*TOLEDO CITY
PLAN COMMISSION
REPORT*

September 11, 2014

| 1. SPR-29-14: | Major Site Plan Review for new multi-family building at 1500 College Drive, 3315 Valleston Parkway, 1517-1519 Secor Road and 1461 Secor Road (part) (bh) |

SITE PLAN

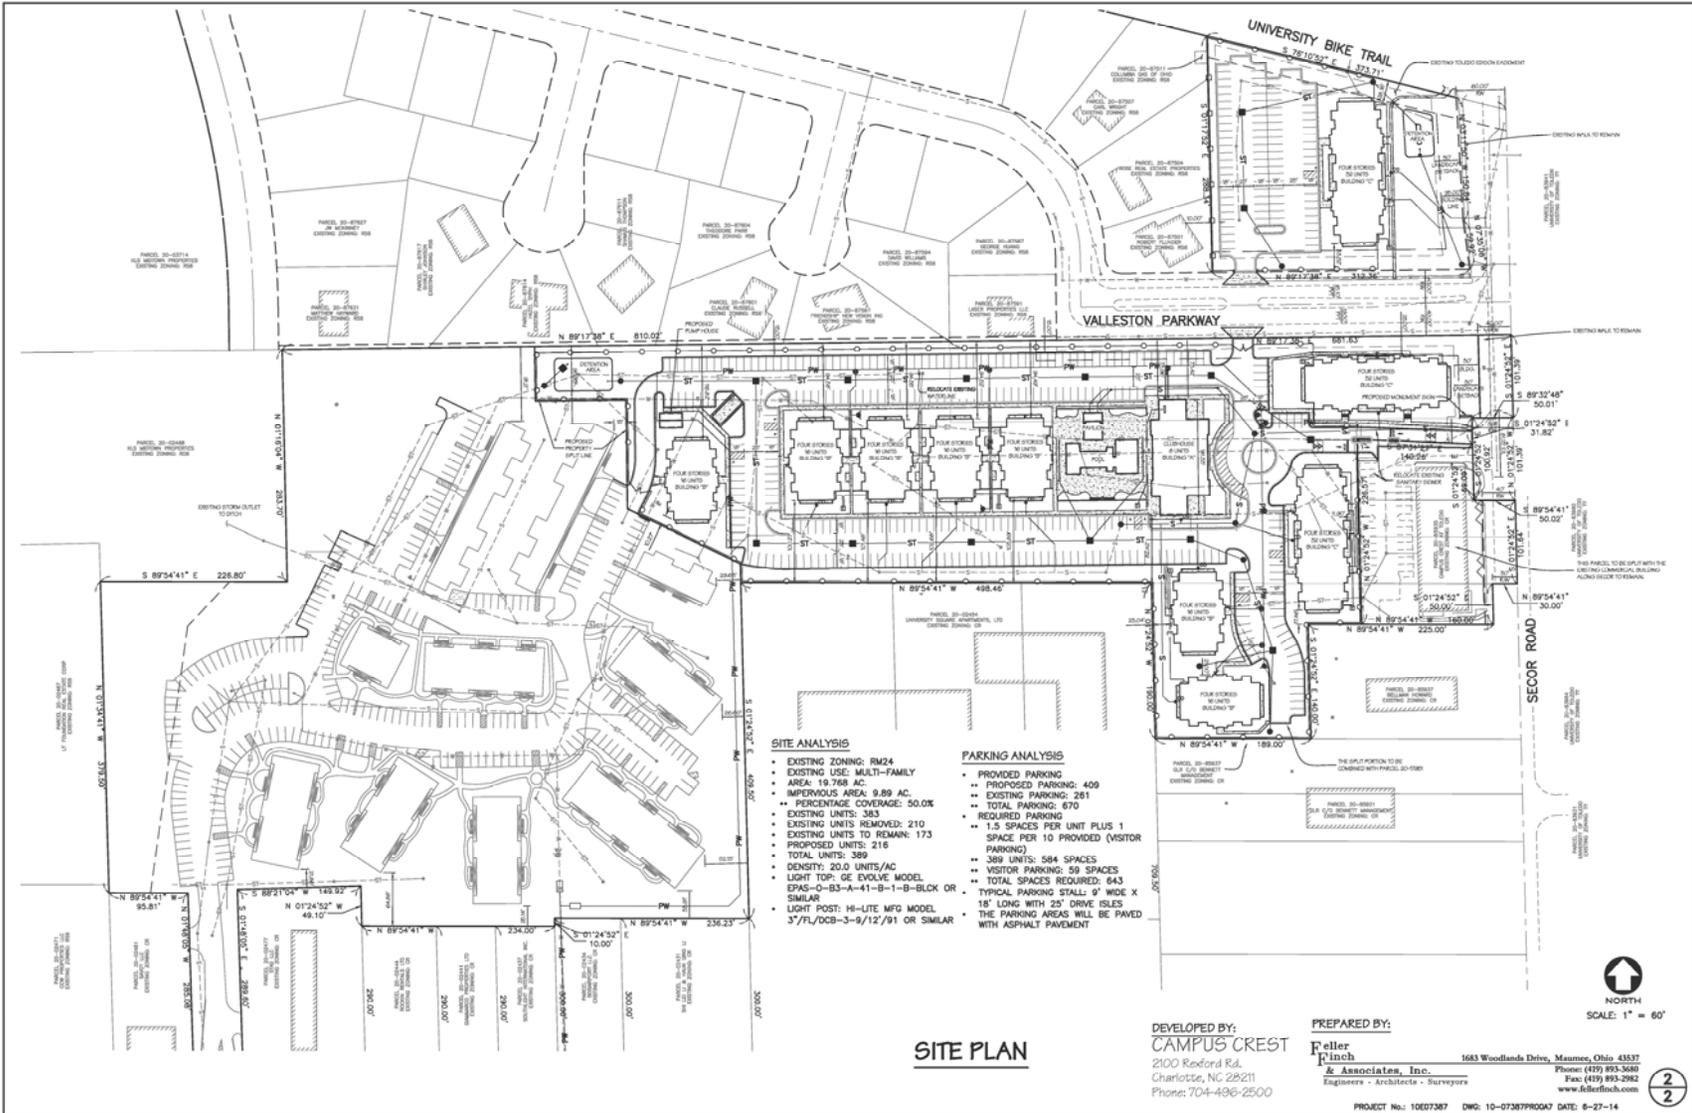
TMC§1107.0304 *Off-Street Parking Schedule “A”* requires one and one-half parking spaces per unit plus one parking space per every ten units for visitor parking. The amendment includes a reconfiguration in the parking area layout in the vicinity of the new building. The previous plan had a parking requirement of 616 spaces with 675 being provided. The amendment requires a minimum of 623 spaces be provided. The applicant is proposing 670 spaces a net reduction of five (5) spaces.

35. A concrete curb or permanent wheel stops shall be constructed along the edge of all parking spaces adjoining landscaping area.
36. Dumpster location(s) shall have a concrete pad and be surrounded by a solid wooden fence or a masonry screen enclosure with landscaping and shall not be located in any required setbacks, **shall be noted on revised site plan.**

- a. In addition to the other landscape requirements for buffer areas, frontage greenbelts, and landscaping for parking lot areas, the following shall be provided: one 2-inch caliper tree for every 500 square feet of building coverage (footprint); foundation plantings along all portions of the building that are visible from the public rights-of-way; and landscaping at all major building entrances; **shall be noted on revised landscape plan.**

- b. Total interior landscaping shall be twenty (20) square feet per parking space. Landscape areas within the parking area shall be peninsular or island types and must be constructed with six (6) inch by eighteen (18) inch concrete curbing; **shall be noted on revised landscape plan.**

SITE PLAN & ELEVATION

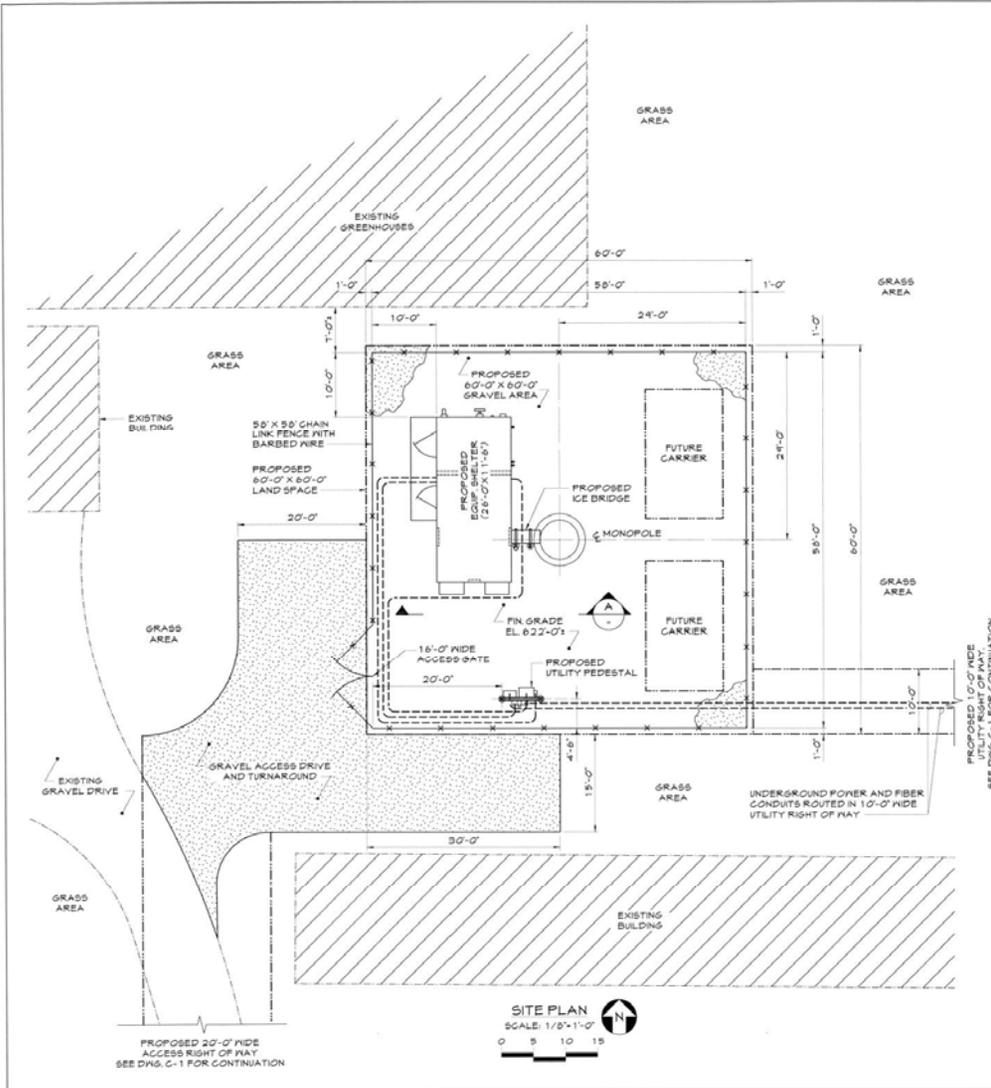
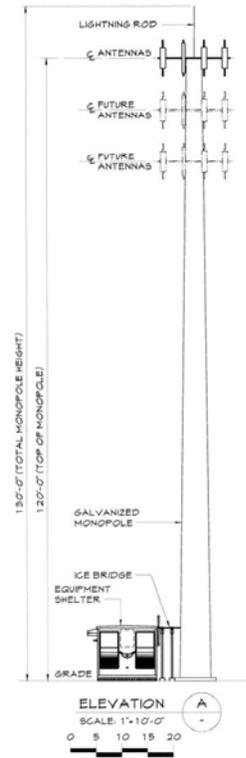
Wireless Facilities are required to have a setback distance from the property line in all directions equal to the height of the tower. The elevation submitted shows a tower that is 130' tall and setback ±124' from the eastern property line. The tower will need to be shifted 6' to the west to be in compliance with the required setback. The site plan indicates existing gravel access roads and a proposed gravel turnaround will be utilized as ingress and egress for the facility. The Toledo Municipal Code requires all drive aisles to be paved with a dust free material. The proposed gravel turnaround is required to be paved with a dust free material.

The site plan and elevation indicates that the proposed wireless cellular tower will be of a galvanized monopole design. The proposed fencing is chain link with barbed wire. Pursuant to TMC§1105.0303 the use of barbed wire, razor wire, concertina wire or the like is not permitted. Additionally, TMC1108.1801 requires that a privacy fence or wall be installed. The proposed fence does not meet this criteria. Elevations show proposed future addition of antennas to the monopole. The addition of antennas to a wireless facility need not be reviewed as a Special Use Permit amendment but shall comply with all applicable zoning districts.

14. The plans call for barbed wire on the chain link fence. The use of barbed wire is prohibited by TMC§1105.0303, particularly as this location as this property is zoned residential and the adjacent properties are zoned residential.

19. The Wireless Facilities shall be setback from the property line in all directions a distance at least equal to the height of the tower or 100 feet, whichever is greater, if the site is in or abuts a Residential district or Household Living or Group Living areas. **Not compliant as depicted on site plan.**

LANDSCAPE PLAN

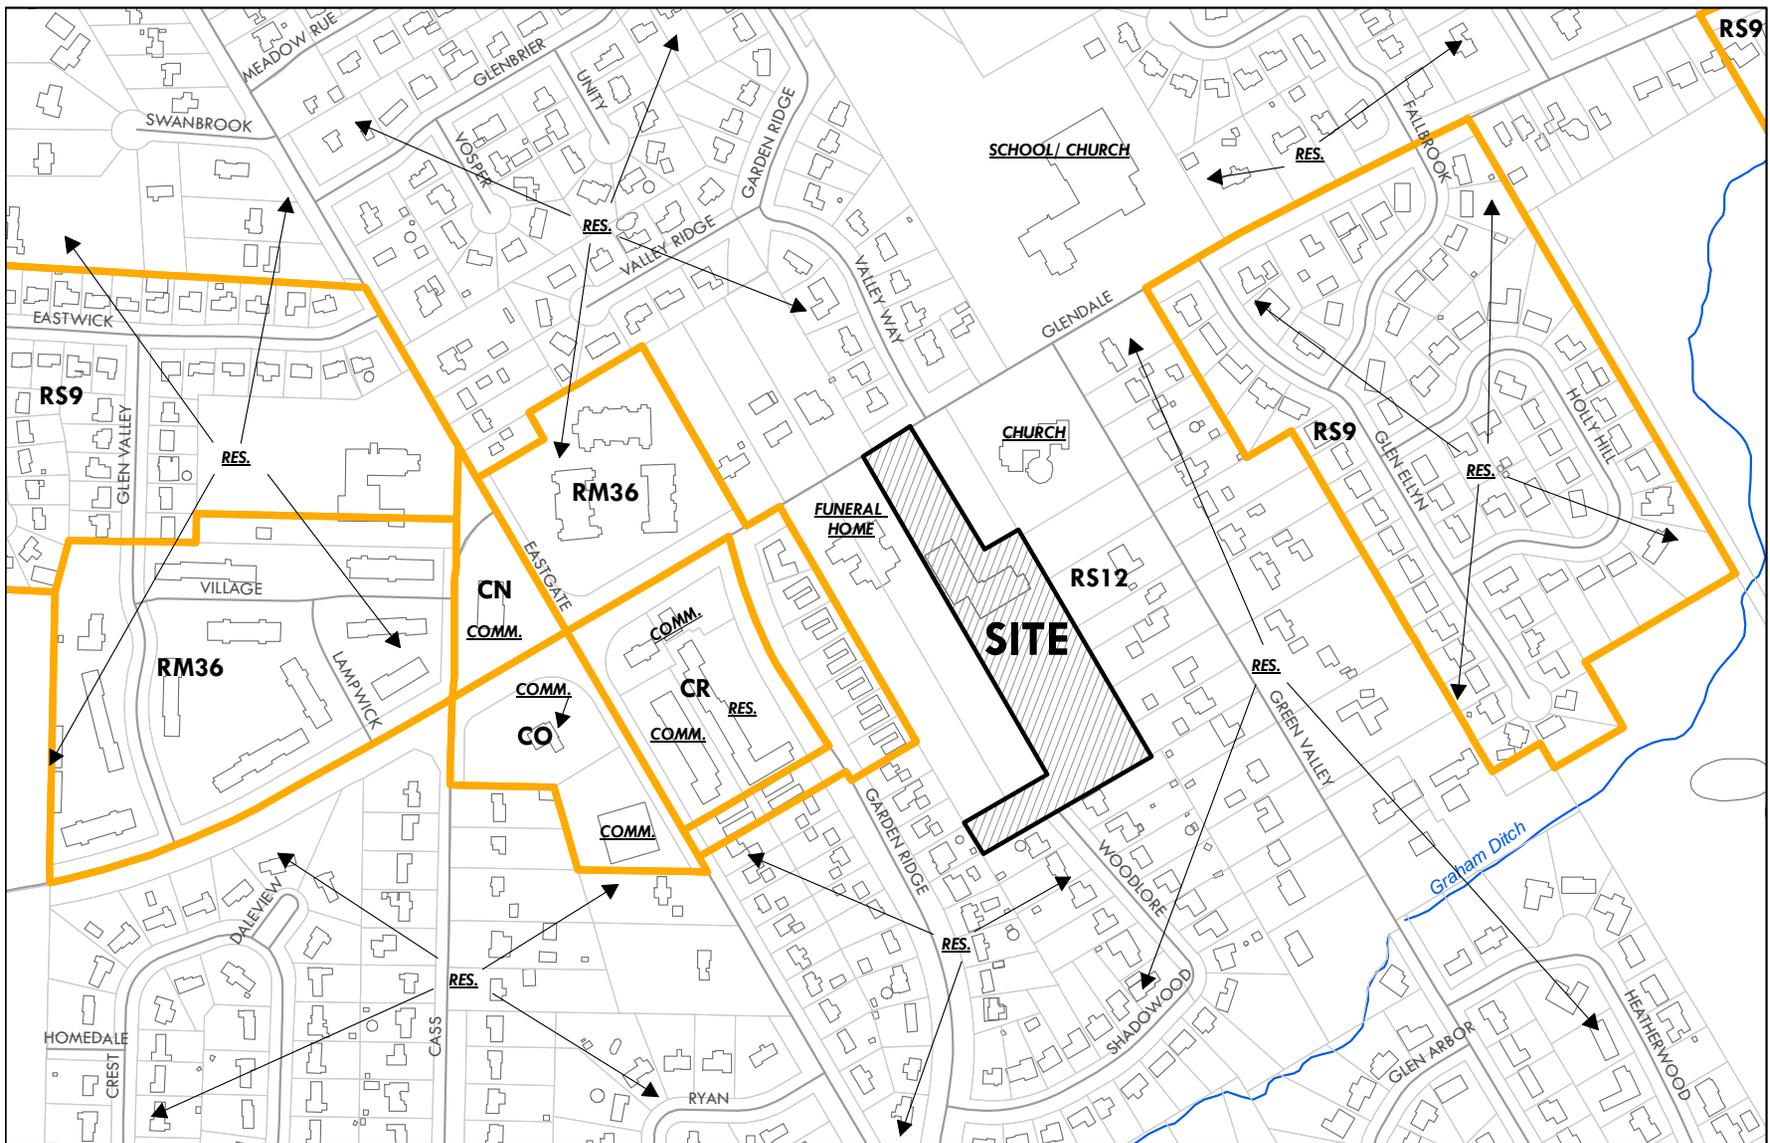
- a. The shrubs required for the Type A Buffer are 4 per every 100 linear feet; **acceptable as depicted on landscape plan.**
 - b. Topsoil must be back filled to provide positive drainage of the landscape area; **shall be noted on revised landscape plan.**

- c. Landscaped areas may not contain bare soil, aggregated stone or decorative rock. Any ground area must be covered with hardwood mulch, grass or other vegetative ground coverage; **shall be noted on revised landscape plan.**

- d. The location, number, height, diameter and species of any materials to be planted and maintained, as well as the location and number of any existing trees to be retained, trees, shrubs, and landscape materials shall meet the standards included in TMC 1108.0400 Landscape Materials Standards; **acceptable as depicted on landscape plan.**

- e. The location, type and direction of any proposed lighting. The lighting is subject to the approval of the Director of the City of Toledo Plan Commission (lights are to be directed away from adjacent residential properties); **acceptable as depicted on landscape plan.**

- f. The location, lighting and size of any signs, all signage is subject to TMC§1387; **shall be noted on revised landscape plan.**
23. A Bond of Performance or suitable assurance acceptable to the Division of Inspection valid for a period of two (2) years shall be posted with the Commissioner of Inspection providing for the installation of required landscaping within one (1) year. Landscaping shall be installed & maintained indefinitely.
